**Attachment D**  
**submissions from service authorities and Council**  
**(exhibited proposal)**

**Re: Lot 7923 (94) Todd Street Alice Springs Town of Alice Springs**

**RE: PA2024/0081 – LOT 7923- 94 TODD STREET, ALICE SPRINGS, NT- 174 DWELLINGS-MULTIPLE IN 5 X 6 STOREY AND 1 X 5 STOREY BUILDINGS, AND OFFICE IN A SINGLE STOREY BUILDING**

**Re: PA2024/0081 174 dwellings-multiple in 5 x 6 storey and 1 x 5 storey buildings, and office in a single storey building**

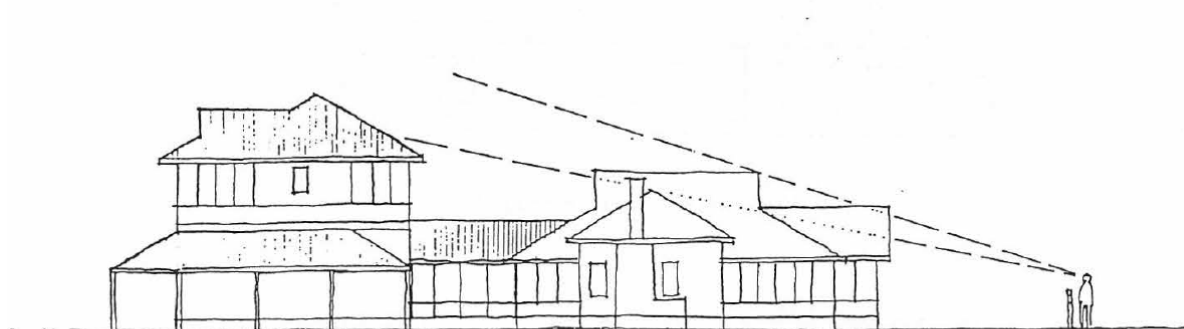
The development has been portrayed as a contemporary counterpart that responds to recognised historic themes of the Precinct, that is, the provision of government housing. Heritage Branch does not accept that the 'residential component' of this development is a modern continuation of the heritage themes/values of the Precinct. The proposed development does not address the rare built forms, scale, architectural character or formal landscaping of the Precinct. Nor does it demonstrate special associations with health, law and order in remote regions or spiritual associations.

Akeyulerre (Billy Goat Hill) and Tharrarltneme (Annie Meyer Hill) are in proximity to the proposed development. These two sites are included within the boundaries of declared heritage places and both are protected under the *Northern Territory Aboriginal Sacred Sites Act 1989*. Further consultation with the Aboriginal Areas Protection Authority and Lhere Artepe Aboriginal Corporation should be undertaken to consider, from an Arrernte perspective, the impact on the relationship between the two cultural sites & views towards and between them. This would be in accordance with the Central Alice Springs Area Plan, and with the Aboriginal Cultural Heritage values articulated in the Statement of Heritage Value for the Precinct.

Limits on the scale and location of the development will be a key consideration for it to be sympathetic to the historic values of the adjoining Heritage Precinct. These values are outlined in the Statement of Heritage Value and further discussed in the Conservation Management Plan (CMP) for the Precinct.
